MEMO

Date: August 21, 2008
To: North Dakota Public Service Commission
Copy To:
From: Kadrmass, Lee & Jackson, Inc
Re: **Addendum: Changes to Application for a Certificate of Site Compatibility (Luverne Wind Farm)**

Summary:

The Certificate of Site Compatibility for the Luverne Wind Farm was previously submitted to the PSC on May 19, 2008. Since the time of submittal, changes have been made to the type of wind turbines used and their locations. The original text from the PSC application, along with the revised text, is listed below in order as they appear in the application.

Figure 4 Project Design

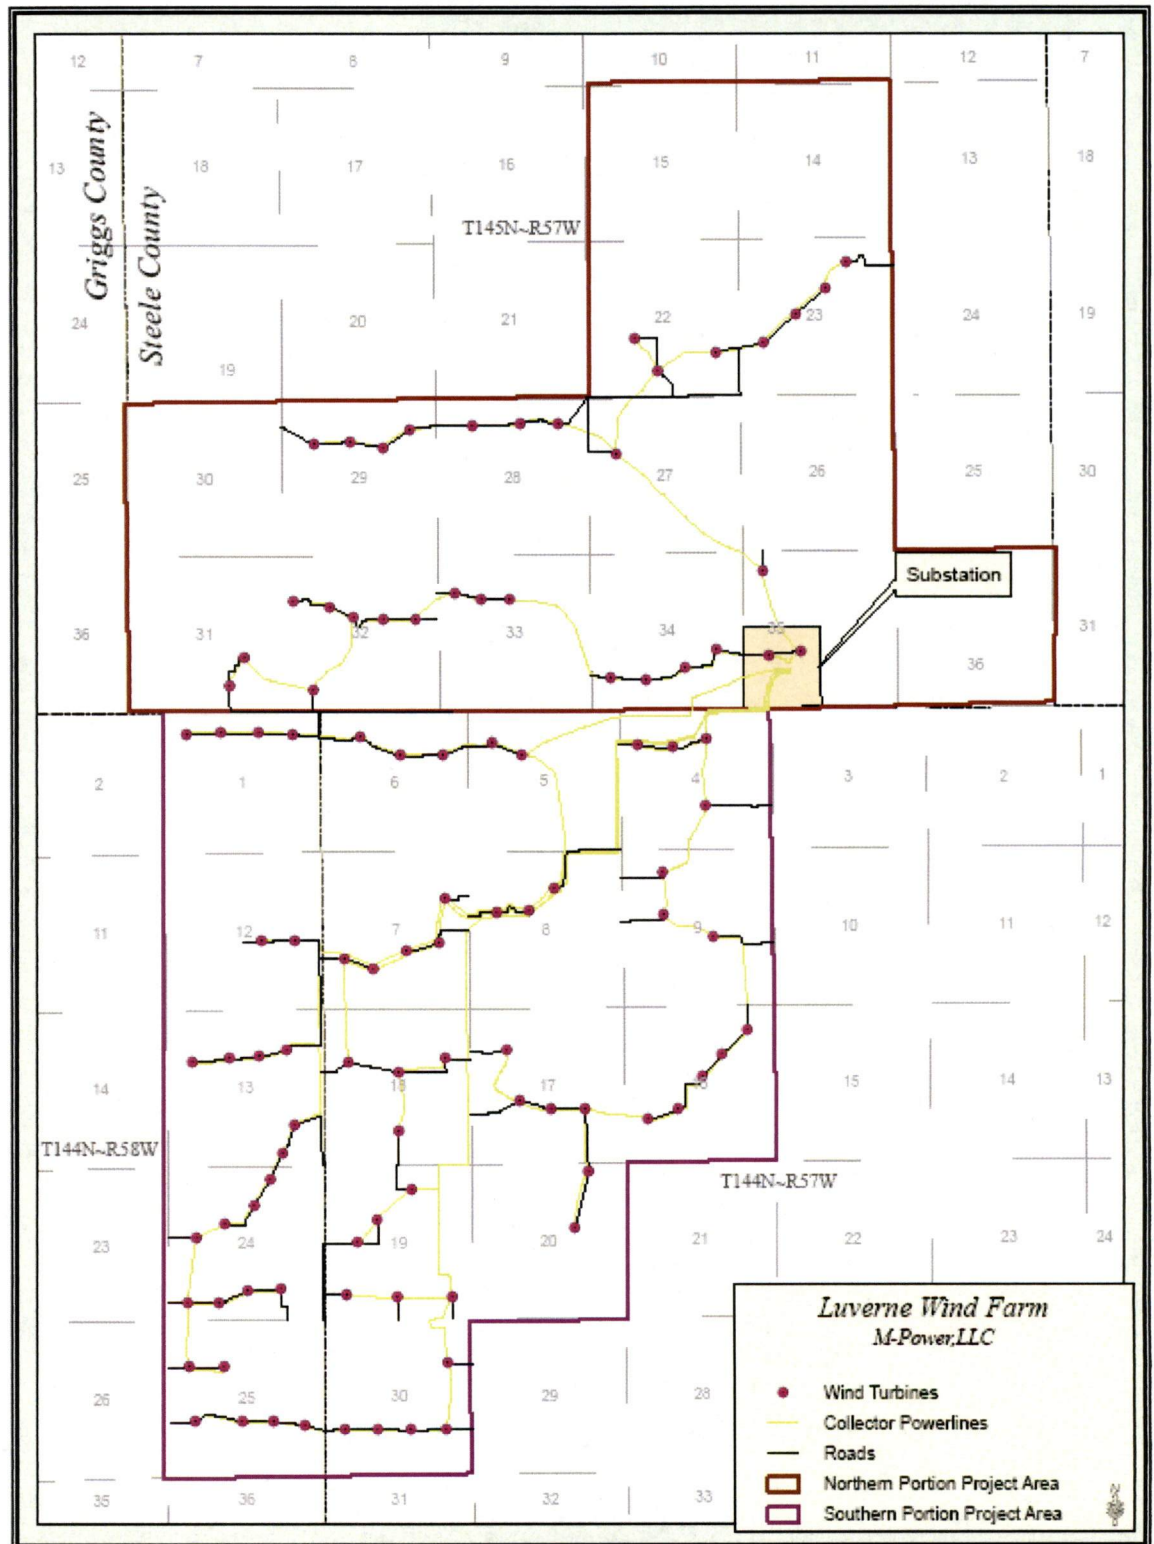
Description of Change 9: Figure 4, Project Alternatives, has been updated to include the new turbine design and configuration. In addition, the title of the figure is changed from Project Alternatives to Project Design.

Description of Change 4: The Collector Line section has changed due to the revised orientation of the wind turbines. *Please refer to a new Figure 4, Project Design.*

Description of Change 5: The Project Layout and Associated Facilities section is updated to correlate with the new turbine orientation. *Please refer to a new Figure 4, Project Design.*
